OBJECTIONS AND COMMENTS ON DA 2023/1832

By Robert Story and Susan Duncan, additional to Helen Monks,
Town Planner

5 PORTIONS, LOVETT BAY NSW

DRG-01
LEPLASTRIER HOUSE
NEIGHBOUR INTERACTION

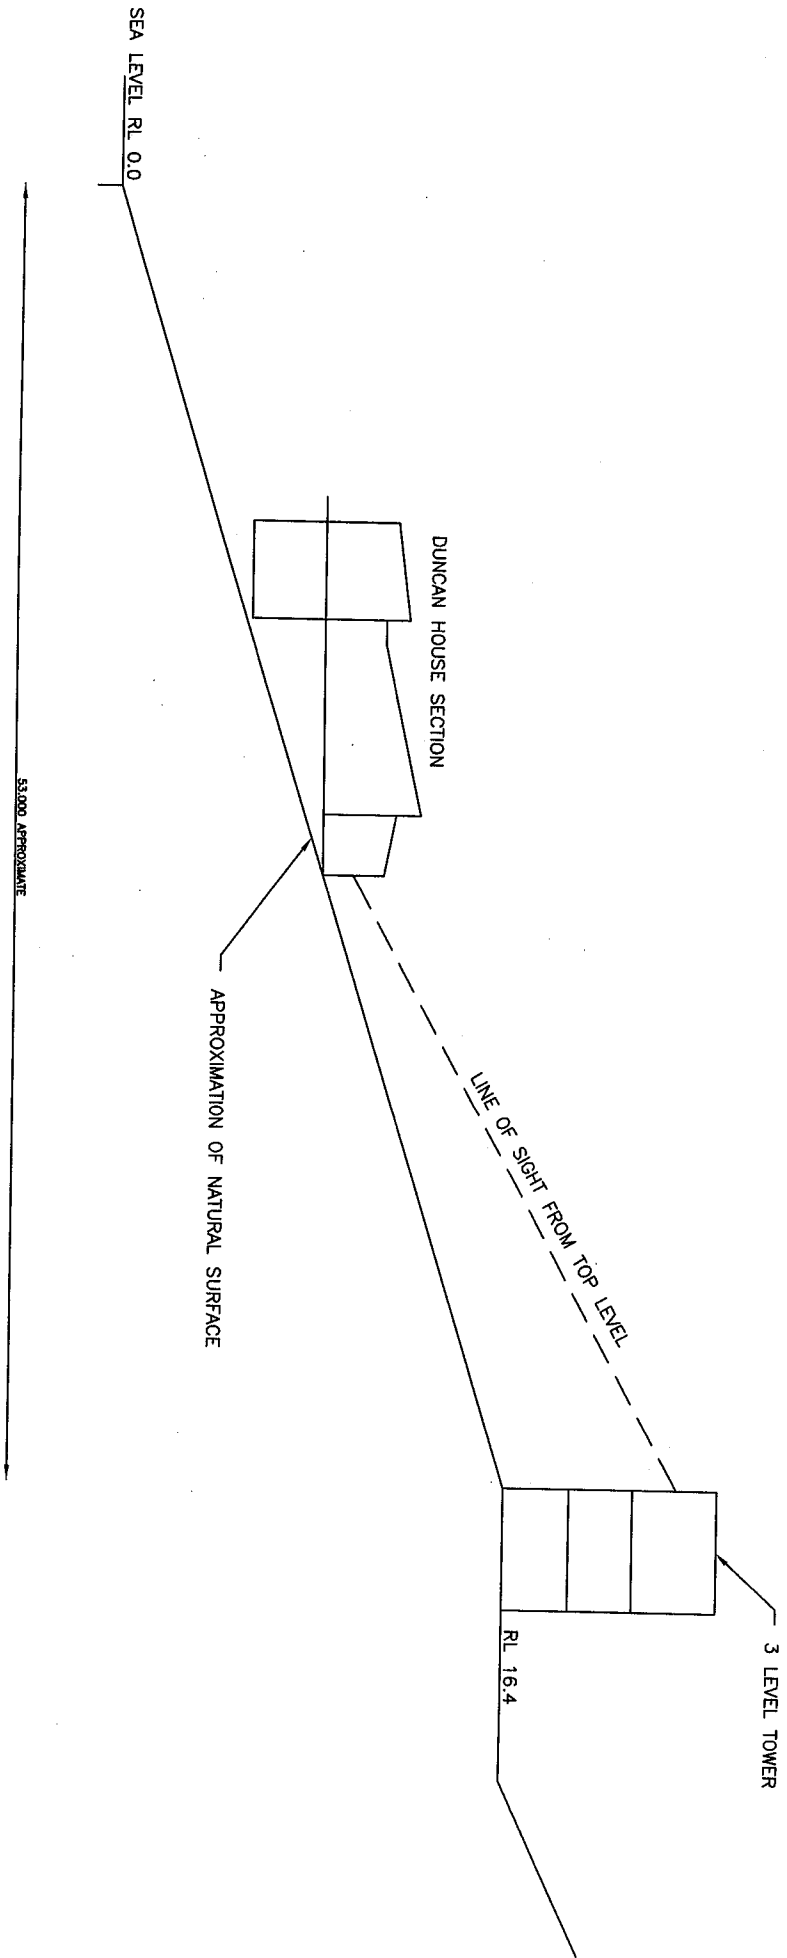
2.7 Exposure: Steep terrain (45 degrees) above Lot 5 means there is virtually no sun in winter (see drawing DRG-01). The absorption trench would be shadowed by the house for more than six months of the year. This makes 2.7.1 site exposure limitations moderate.

2.8 Slope: The average slope from seashore to the back of Lot 5 building area is approximately 20 degrees which makes Lot 3 and Lot 6 vulnerable to significant leakage of the proposed absorption trench. Refer to drawing DRG 01 for trench location.

DRG-04
ACTUAL SLOPE

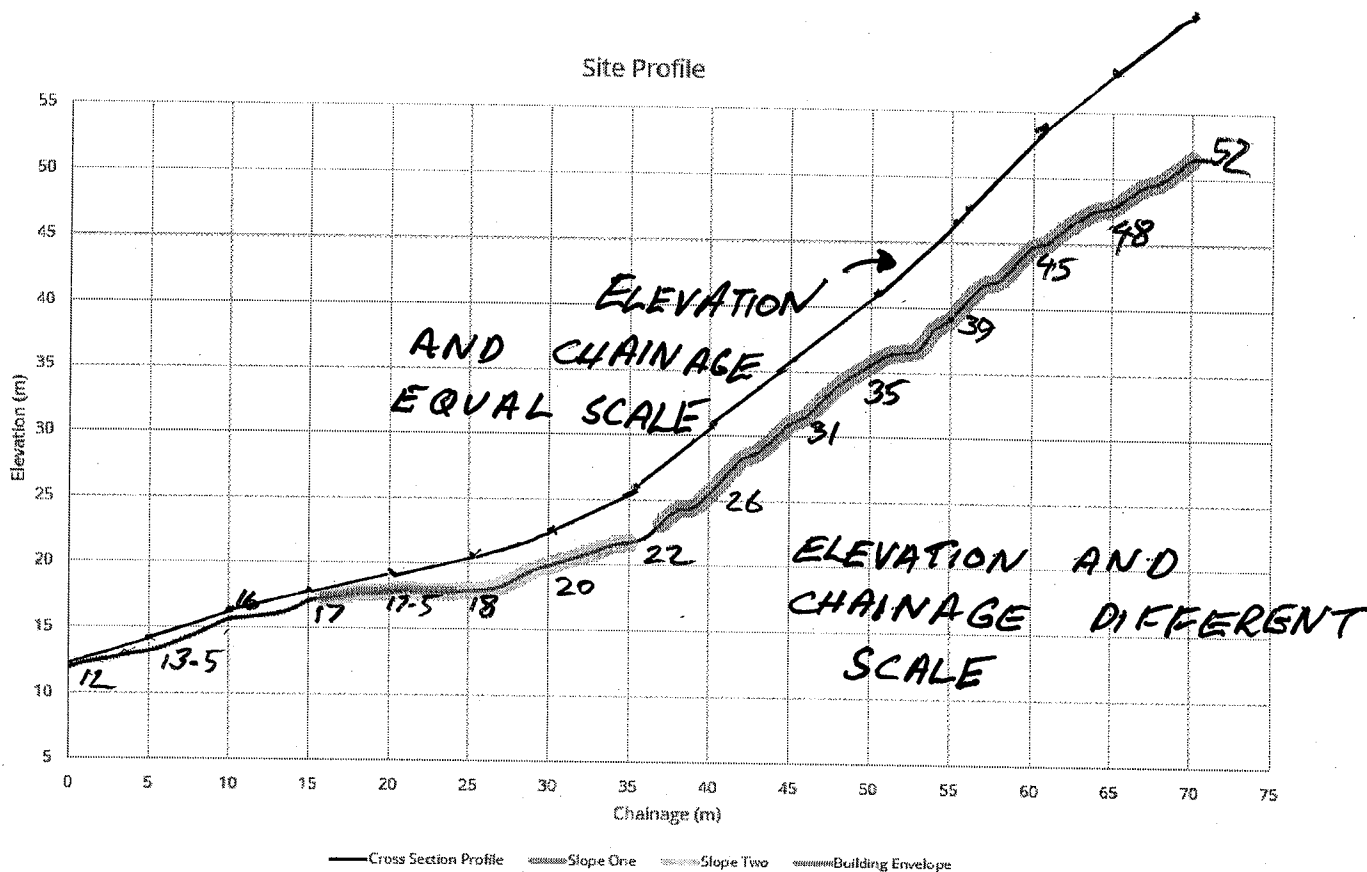
Figure 3.1 profile cross-section is misleading. The elevation and chainage are different scales, giving a shallower appearance of the slope of the land.

Refer to DRG-04 The block is steeply sloping from the water's edge, starting at 20 degrees and increasing to 45 degrees.

There are several horizontal benches or terraces cut into this slope but they do not affect the overall steepness of the block.

DRG-05 BOUNDARY ERROR
APPENDIX A

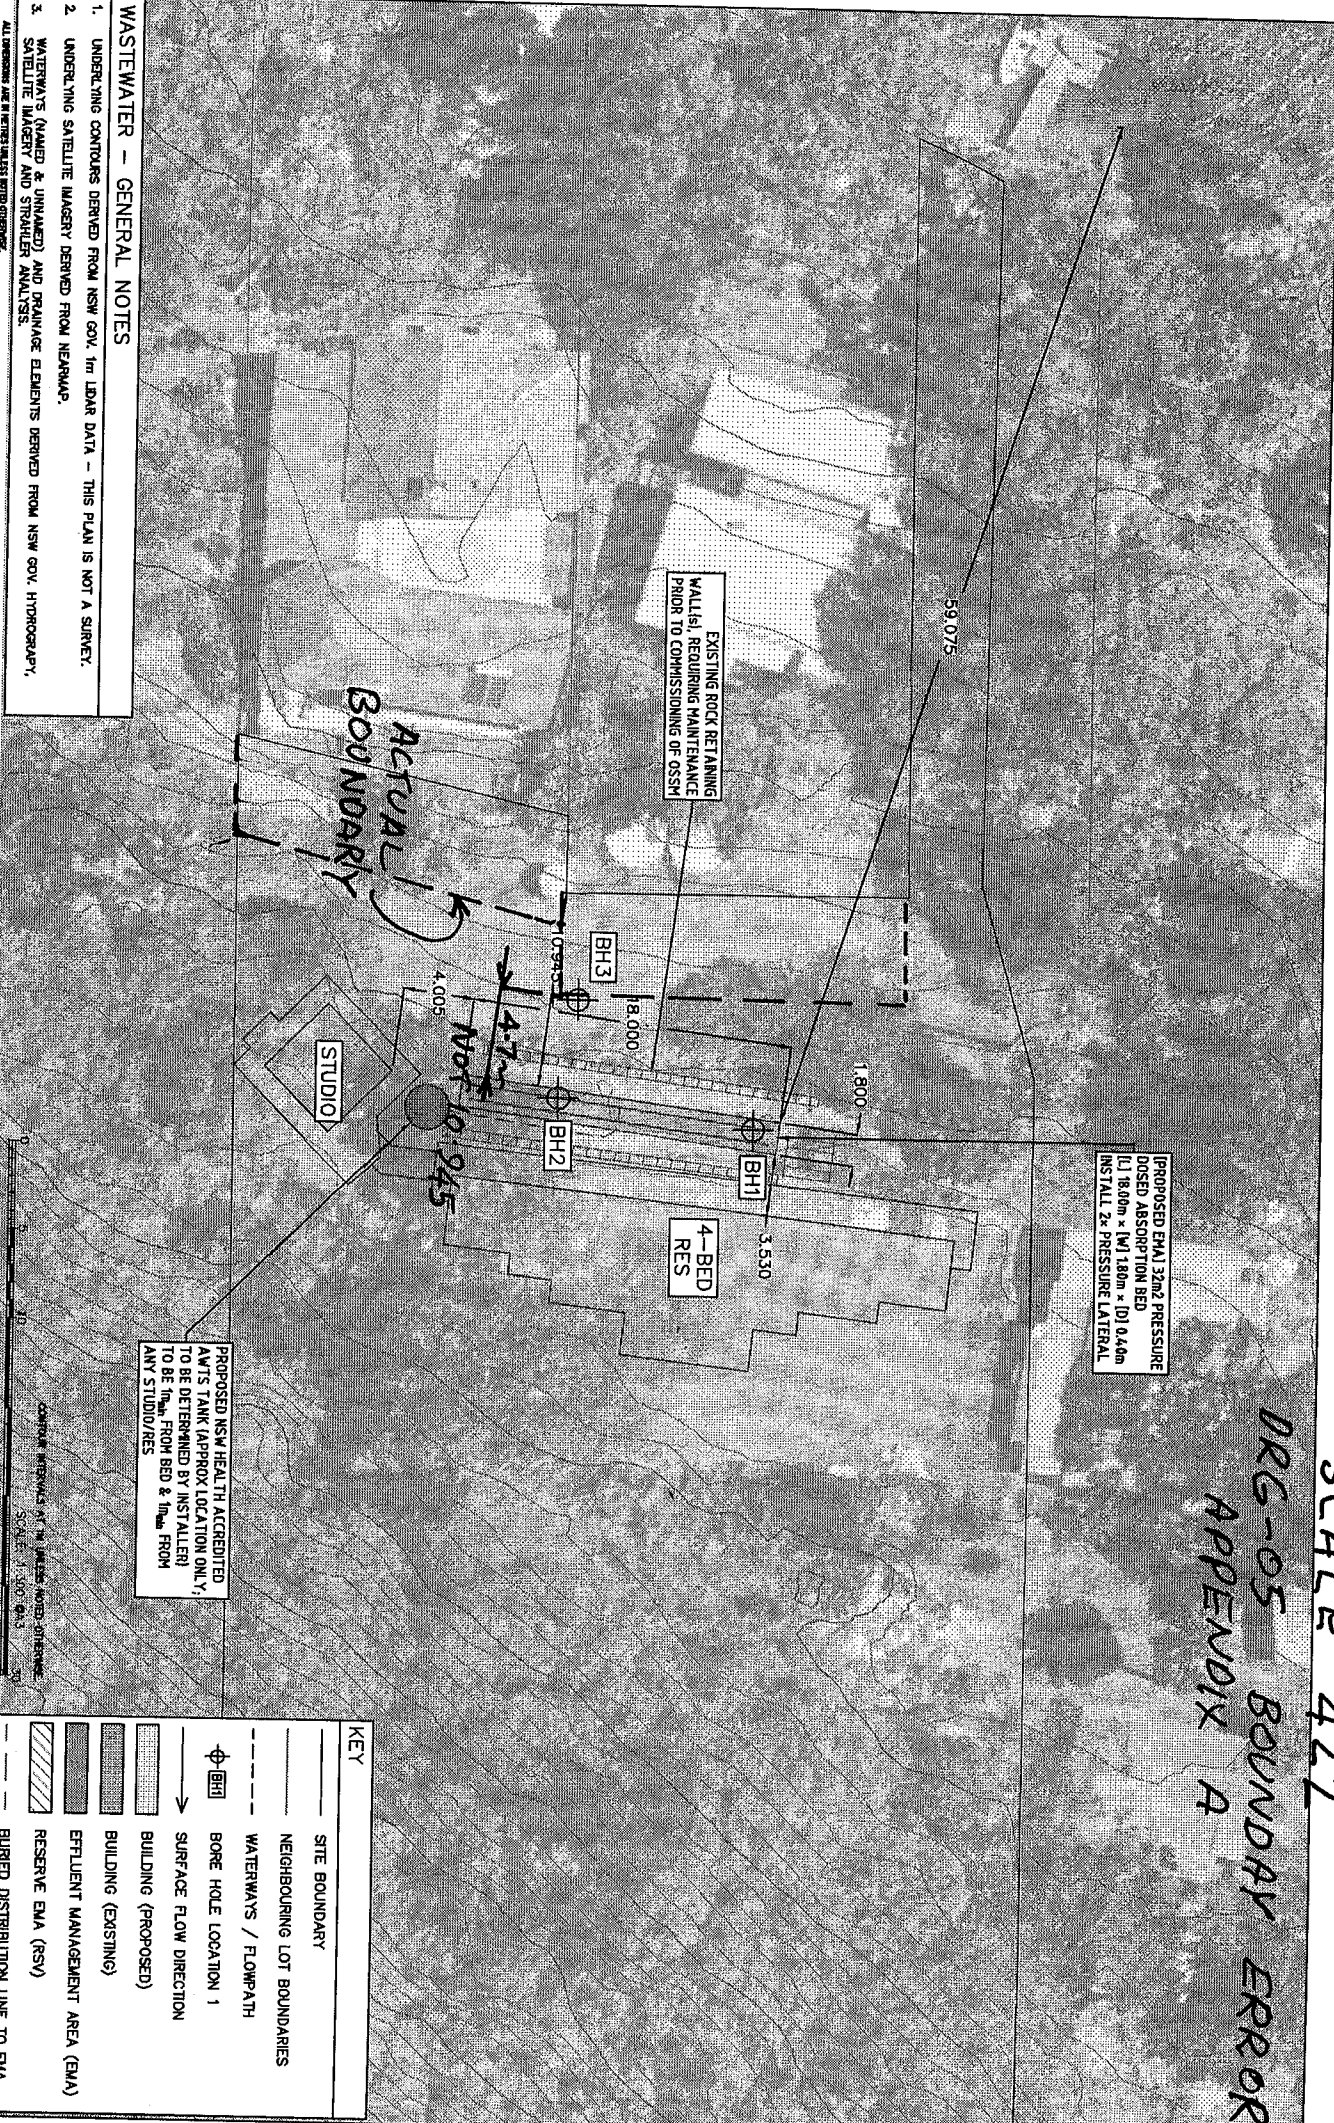
E Position of land application area in landscape: boundaries are incorrectly shown on Appendix 1 and are out by a distance of **7 meters**.

Appendix 1: Boundaries of Lot 3 and Lot 6 incorrectly drawn and show a major discrepancy of 7 meters. See drawings 5 & 6.

1. EMA is far too close to 3 Portions boundary and must be located at least 12 meters off this boundary.
2. Appendix 1 of the wastewater report shows the Portion 3 property boundary to be approximately 7 metres south of the actual location.

DRG-06 LOCATION EMD PART OF LB4

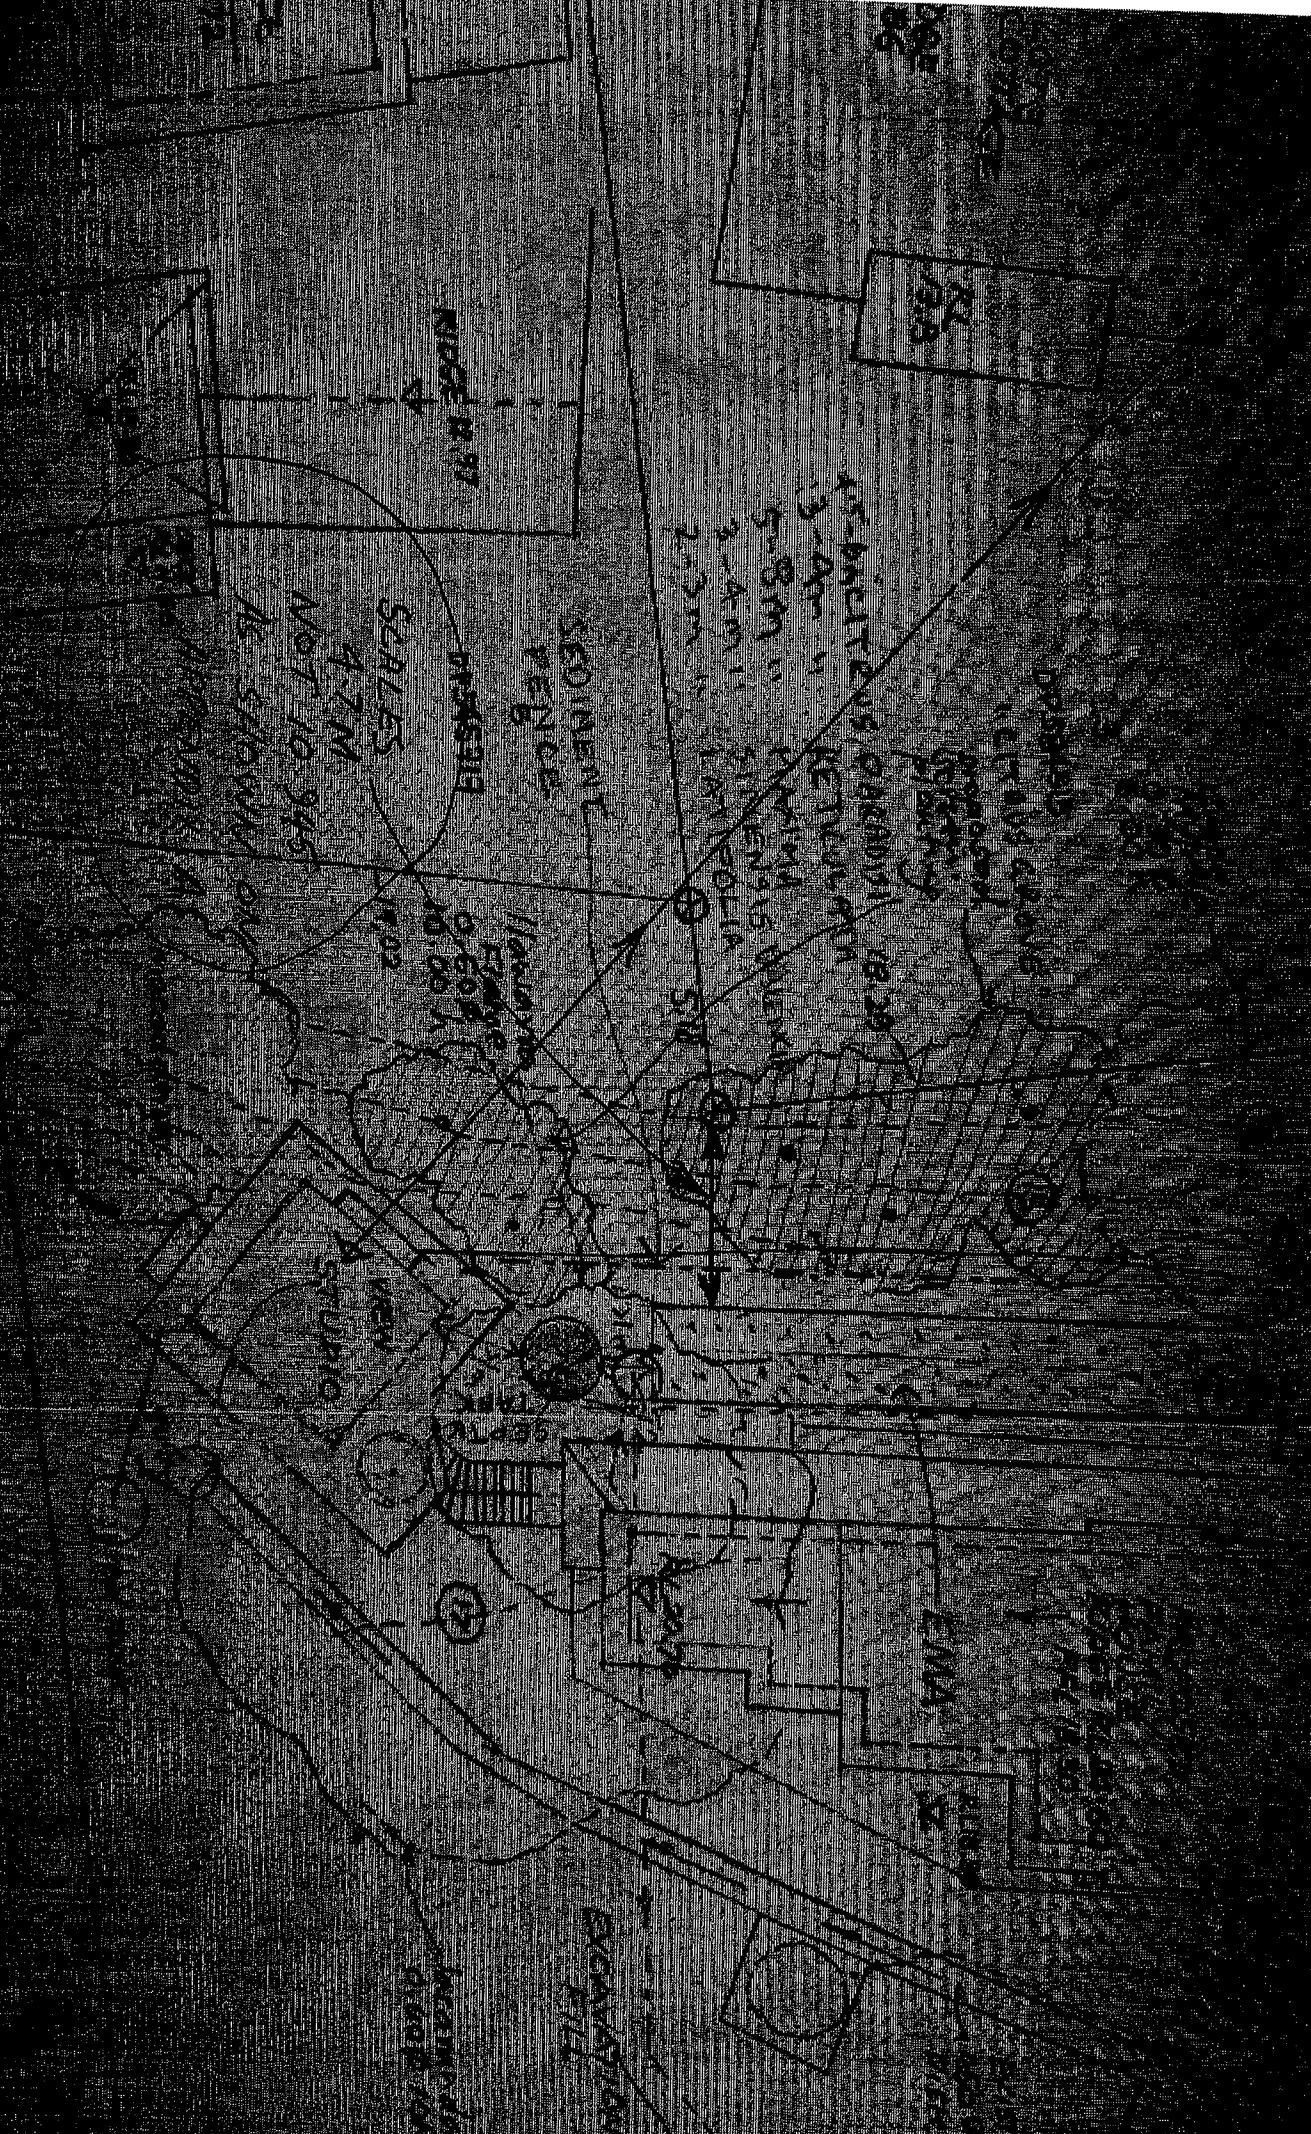
2.17 Buffer Distance and Available Land Area: EMA is on the upslopes of Lot 3 and Lot 6 and the **twelve-meter** set-back must be observed. The EMA as shown, is on a narrow strip above an average slope of 20 degrees slope.

DRG-07 SHADOW LINE

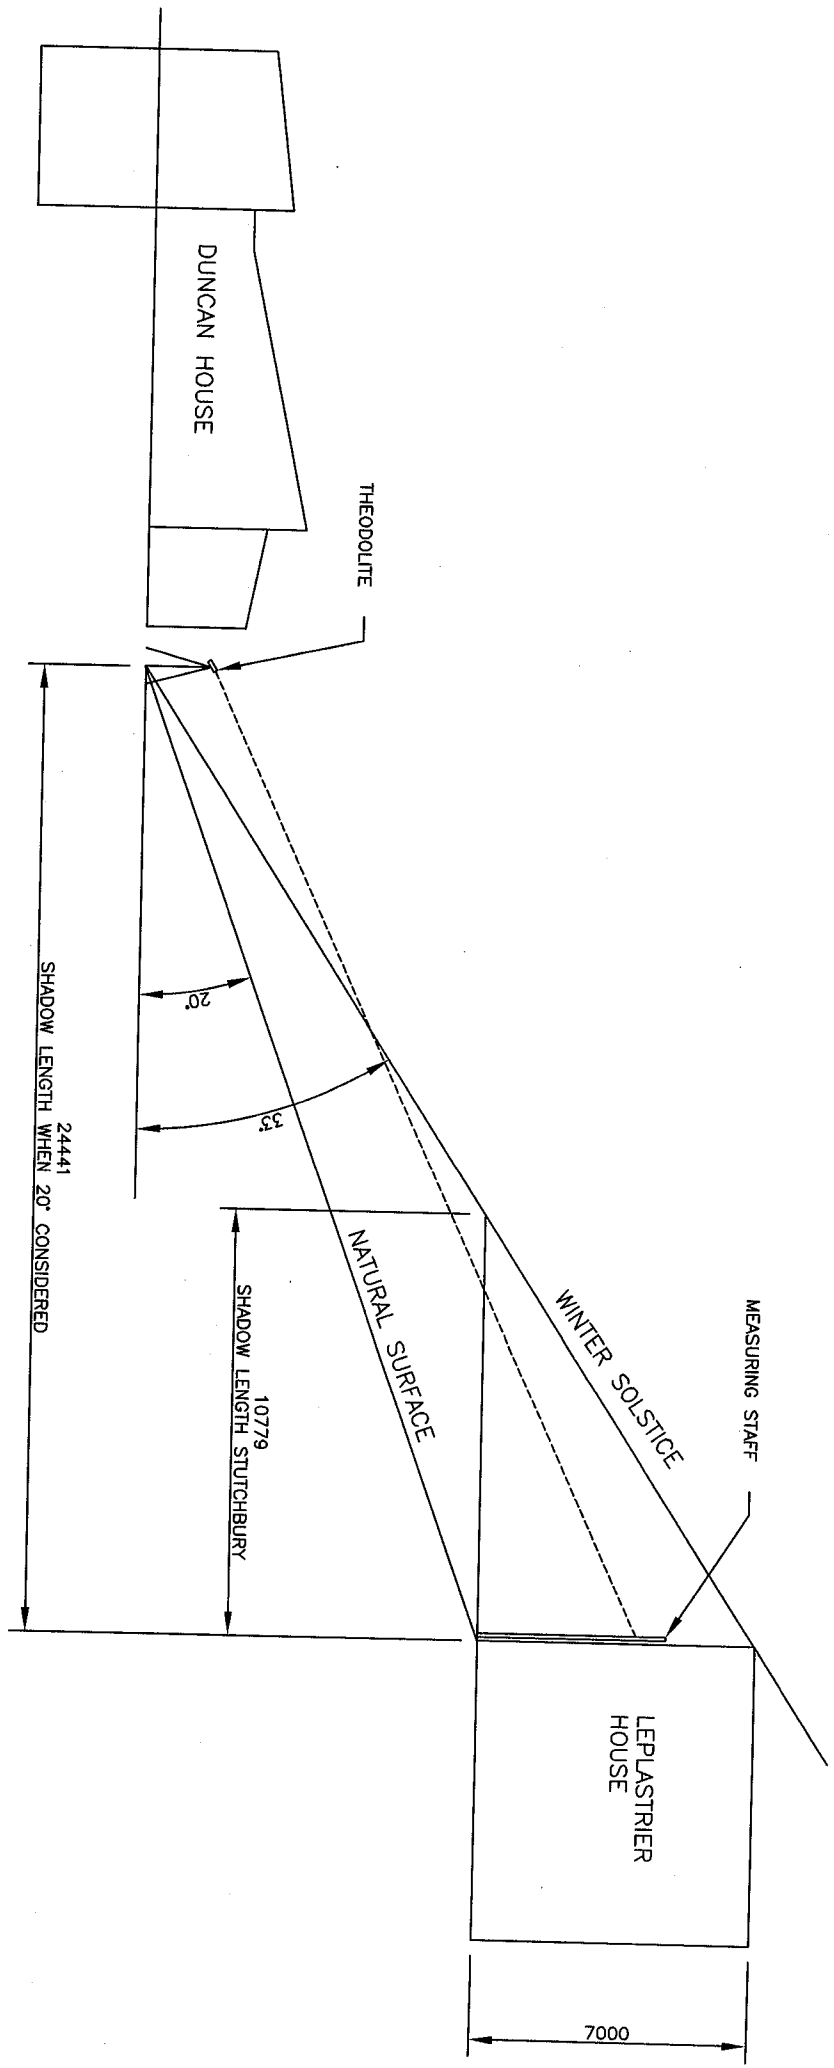
There is a fundamental error in the shadow lines provided. *See DRG 01, 07,08.*

Analysis does not take into account that the land between 5 Portions and 3 Portions, falls steeply away at around 20 degrees. The shadow lines chase the sloping land until the shadow line catches up. Shadow length is around 11 metres, whereas I have calculated a shadow of approximately 25 metres. **See DRG 07.**

We can argue the correct shadow length, but the simplest solution is to carry out a site measurement. A theodolite can be set up at the Duncan House to sight a measuring staff at the Leplastrier designed building at the front elevation. Knowing the distance and the angle, an accurate drawing can be compiled. **See DRG -07.** No surveyor is required as I have a theodolite and can do a full and accurate check with a representative of the Leplastrier family.

DRG-08

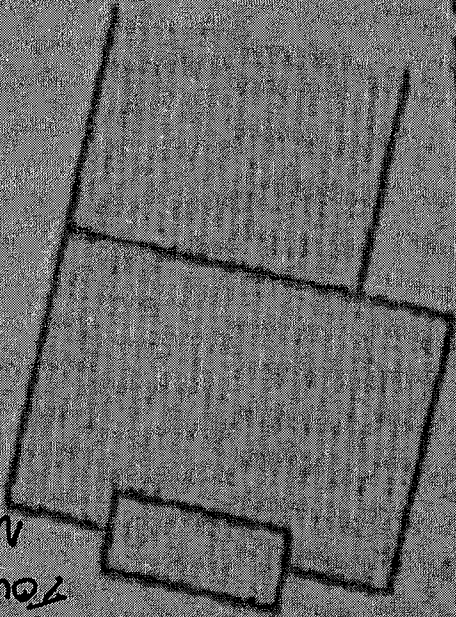
TOWER SHADOW
NOT INVESTIGATE
